North Hertfordshire District Council

Building Conservation comments

File Ref: 24/02372/FP

Subject: Installation of replacement North wall and boiler house roof following demolition of existing.

5.1 Drawing no. 2204/50-P Rev A is very well detailed (see extract below).

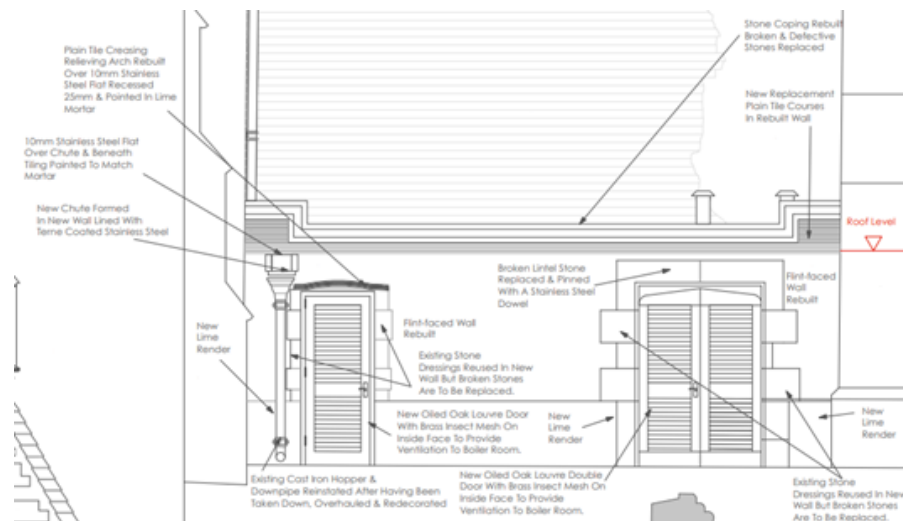
Whilst I raise no objection in heritage terms to what would essentially be a like-for-like replacement externally, is there scope to improve upon the existing arrangement by omitting the stepped parapet and increasing the height of the central section so that there is a single height parapet to screen any new flue projecting from the new boiler room roof?

This matter does not appear to have been addressed in the current submission, but I have received a voicemail from Michael Beare on 23 January stating that the chrome flues will go so will not be seen. In my opinion, there is insufficient reason to pursue this matter.

1. Standard time condition.
2. Following the removal of the section of wall above the steel beam and inspection of the wall below this, and before any further works are undertaken, written confirmation shall be given to the Local Planning Authority as to whether the remaining section of wall is to be repaired or rebuilt.

3. In the event that the wall is to be rebuilt, the existing carstone and flints shall be reused in the new build. Where lintel stones or other dressing stones are incapable of repair and are proposed to be replaced, these shall match the existing stones as closely as possible in colour, texture and detailing.
